Serial No.: 10/788,653

Attorney Docket No.: R1888

Reply to Office Action of: 08/29/2006

REMARKS

FIG. 4

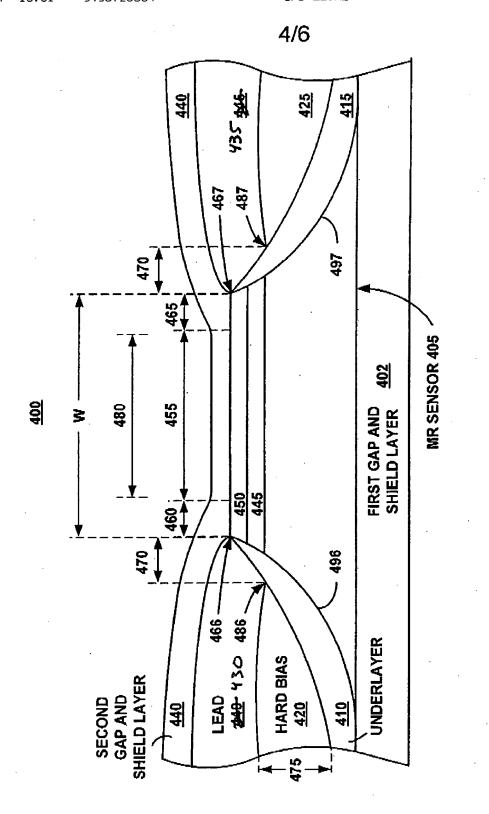
The Examiner has objected to Fig. 4 because the leads 430 and 435 were mislabeled as 440 and 445, respectively. Applicants have corrected this error in amended Fig. 4 (see the clean and marked-up versions of Fig. 4 reflecting this amendment in Appendix A of this response). Accordingly, Applicants respectfully request reconsideration and withdrawal of this objection.
